URGENT – FIELD SAFETY NOTICE
Concerto & Basic shower trolley

Date:	2019- MMM-DD
Product Issue:	Concerto & Basic shower trolley – Potential unintentional drop of safety side panel
Affected Product:	<ul style="list-style-type: none"> ✓ Concerto & Basic shower trolleys manufactured between November 2018 and June 2019; Serial number ranges: P0512263 to P0551621 ✓ Concerto & Basic shower trolleys fitted with the affected spare parts (safety catch) part no. 8451622, 8546608, S8533571-031, S8533572-031, S8533570-031 S8542201-014, S8523559-031, 100-805-03, 100-806-03 during service between 2019-Nov-27 and 2019-Jun-14
Affected Serial No.:	Attachment A
Resolution:	Safety catches replacement in order to ensure the device is operating safely
Field Safety Notice:	FSN-POZ-002-2019
Pages:	3 & Customer Response Form

Reference: Concerto & Basic shower trolley – Potential unintentional drop of safety side panel

Image 1

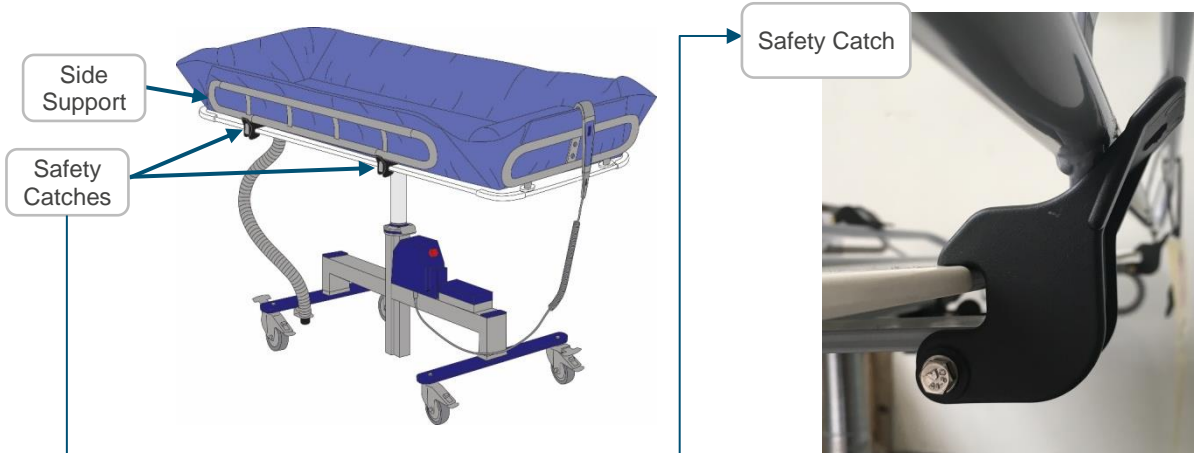
Each Concerto & Basic shower trolley is equipped with two Side Supports, one on each side of the shower trolley (Image 1). Each side support is secured by two (2) Safety Catches (Image 2) which are used to fold down the supports as well as secure the support in the raised position.

Arjo has become aware that any of the 4 Safety Catch(es) may exhibit a mechanical failure (break in one of the arms of Safety Catch), which in certain circumstances may contribute to the Side Support unintentionally opening and may lead to a potential risk of patient fall, leading to possible injuries to patient and/or caregiver.

1. Verify the condition of all 4 Safety Catches attached to your device. If you notice the break (as shown in Image 3) withdraw the trolley from use.

- ✓ It is recommended that the Safety Catches on the shower trolley Side Supports be inspected daily to ensure any of the catches are not broken as show on the Image 3.
- ✓ The patient is not left unattended at any time.
- ✓ The patient is fully assisted so that he/she does not grab, push or lean against the Side Supports during showering activities.
- ✓ Caregivers should limit pulling and pushing of the Side Supports with excessive force.
- ✓ **Note:** always adhere to the Safe Working Load as outlined in the IFU.
